This gallery shows some pictures of bad solderings - they should prevent you from making the same errors (feel free to add even more pictures here!)

Permanent link:
http://www.midibox.org/dokuwiki/doku.php?id=bad_solderings_gallery

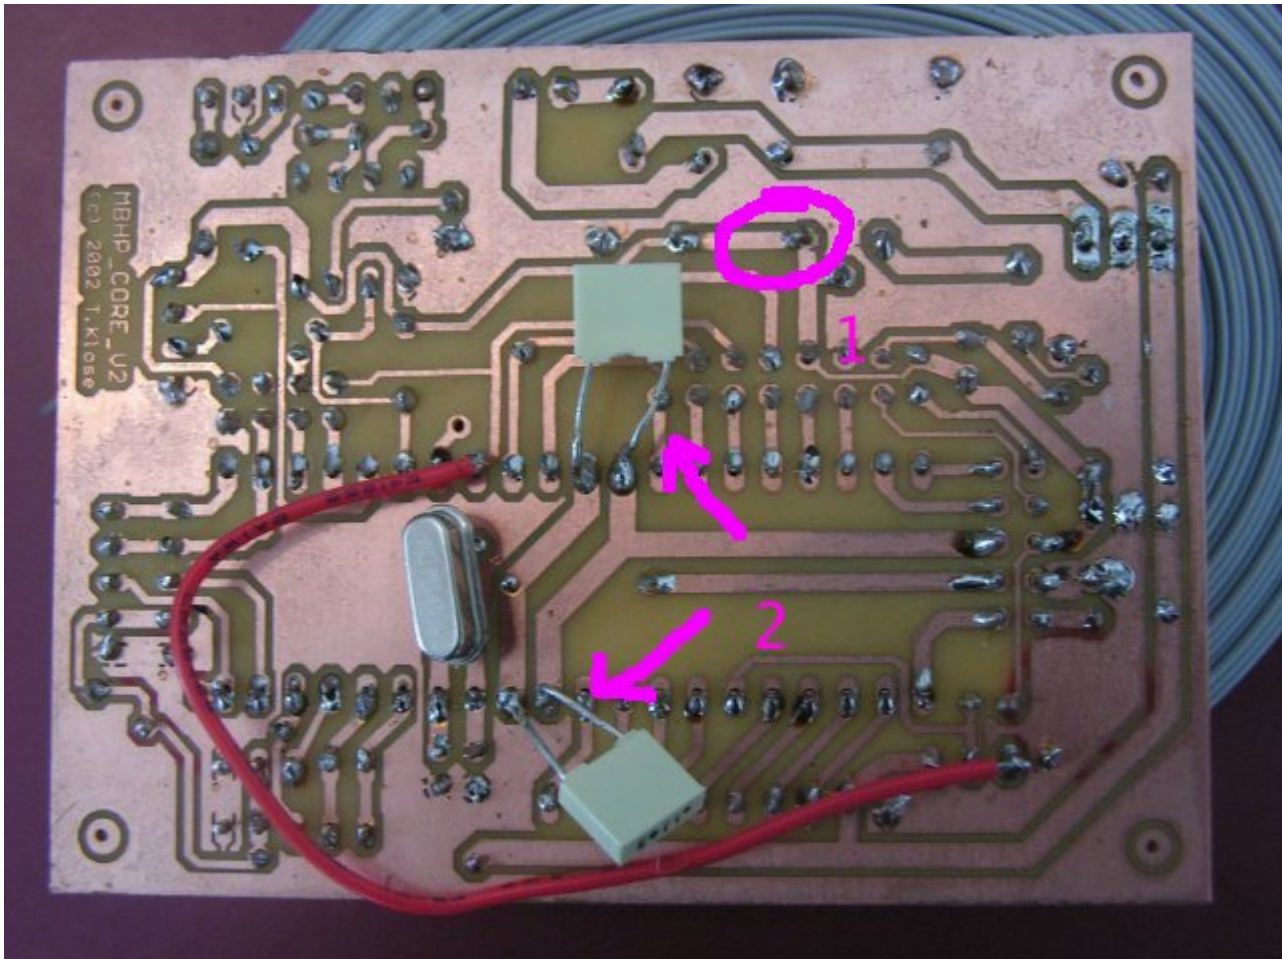
1: The core module has some badly soldered connections(loose), which could lead to failures. There are also missing solderings (e.g. 33pF cap below crystal). It makes sense to solder each pad again, the [Soldering](#) guide in the Wiki gives some useful tips

2: The legs of the caps should be cut, otherwise they can cause a short circuit which can damage the PIC!

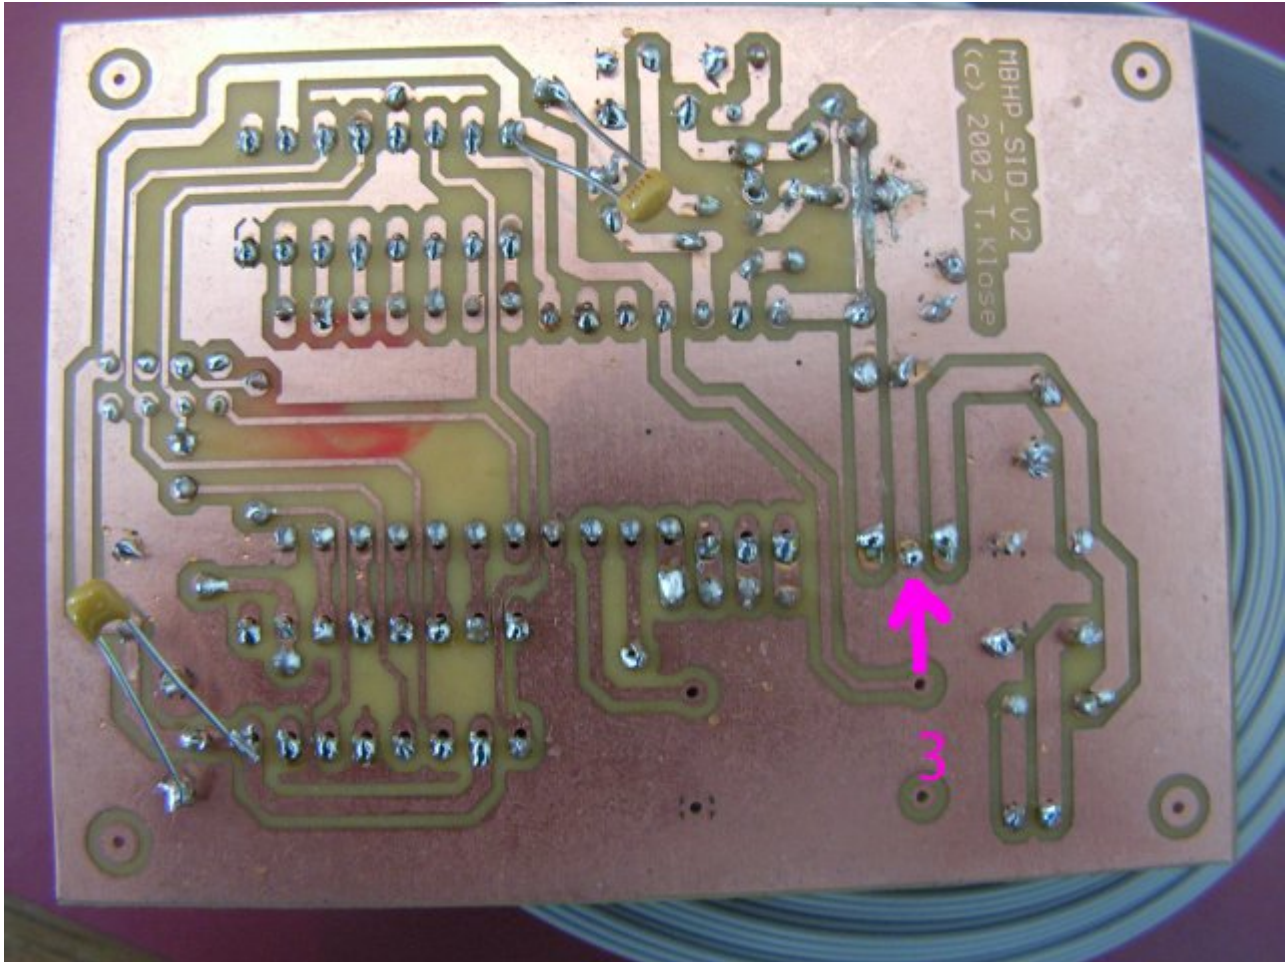
3: This seems to be a bad ground connection directly at the 78xx - it can lead to the wrong voltage. Here the same: just solder the pads again, it will help
And same as above: the long cap legs need to be cut, the danger of shorting out is too high!
